ADDENDUM No. 2

Date: 11/30/2018

DORMITORY AUTHORITY - STATE OF NEW YORK

**ALFRED STATE COLLEGE
BRADDON HALL & PEET HALL
CURTAIN WALL REPLACEMENT AND ASBESTOS
AND HAZARDOUS MATERIALS ABATEMENT
RE-BID
3409309999 CR 4**

CURTAIN WALL TYPE A - 4 TOTAL

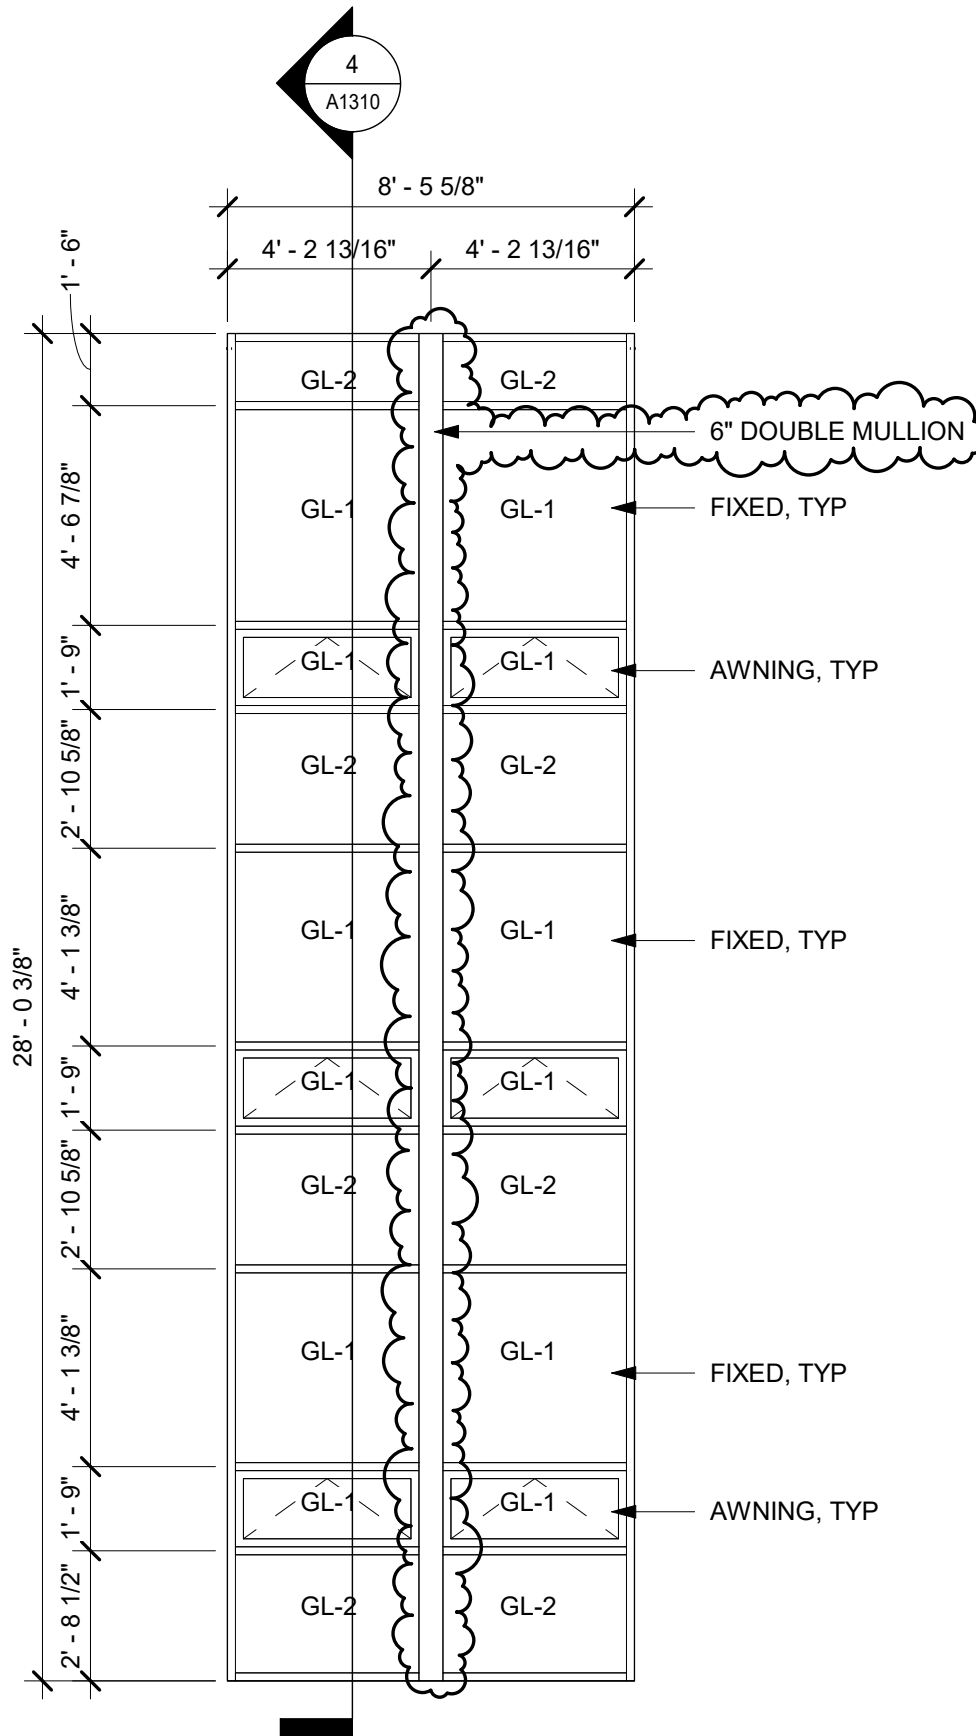
Item No. 3 – Drawing A1200 – Braddon & Peet Halls Typical Exterior Elevations - **REVISE** Elevation 1 – Exterior Elevation – West stair, to modify Curtain Wall type A as indicated on drawing AD2-A01

Item No. 4 – Drawing A1200 – Braddon & Peet Halls Typical Exterior Elevations - **REVISE** Elevation 4 – Exterior Elevation, to modify Curtain Wall type A as indicated on drawing AD2-A01

Item No. 5 – Drawing A1310 – Braddon & Peet Halls Typical Window Types and Details - **REVISE** Elevation 1 – Curtain Wall Type A – 4 Total, as indicated on drawing AD2-A01.

5 MULLION TRIM CAP DETAIL

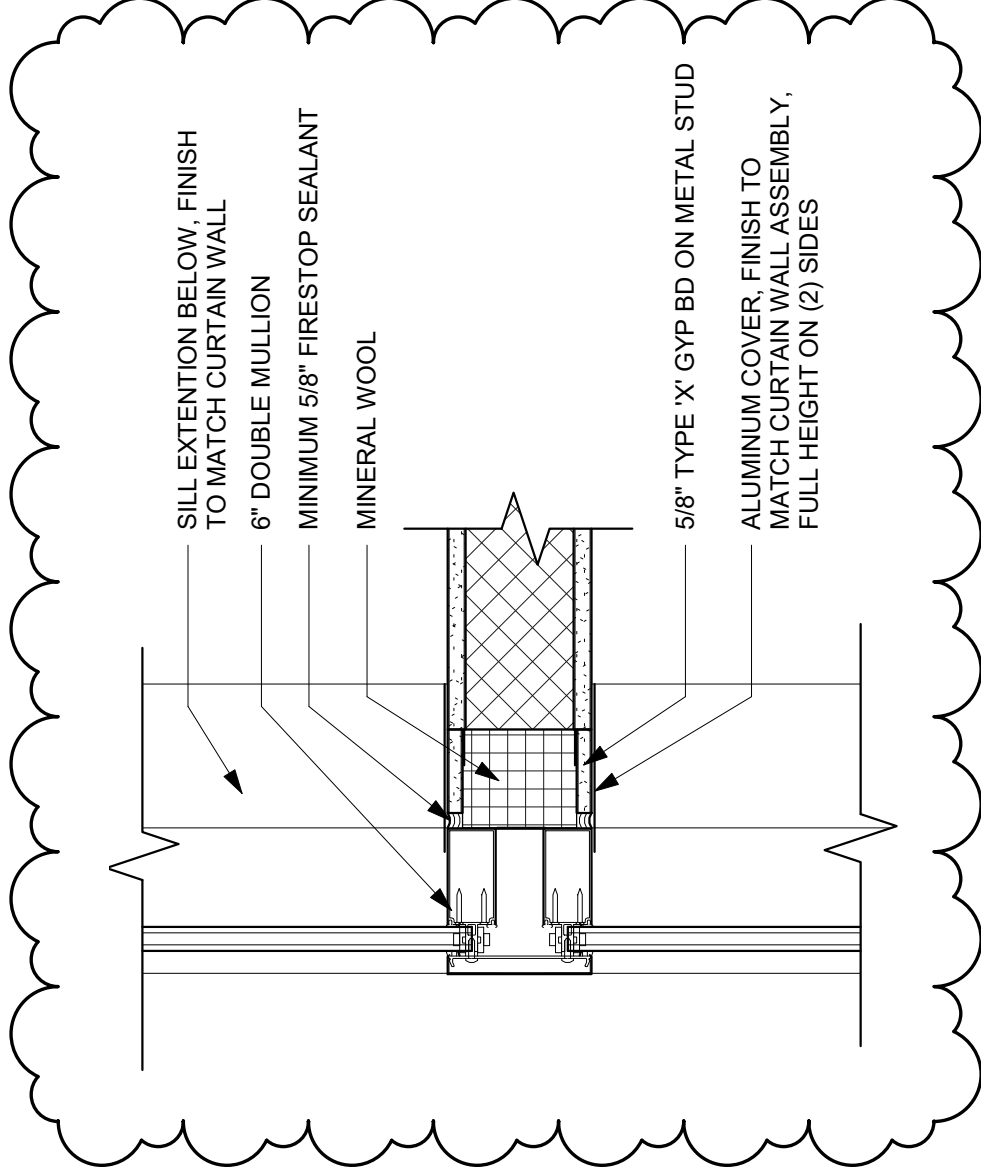
Item No. 6 – Drawing A1310 – Braddon & Peet Halls Typical Window Types and Details - **REVISE** Detail 5 – Mullion Trim Cap Detail, as indicated on drawing AD2-A02.
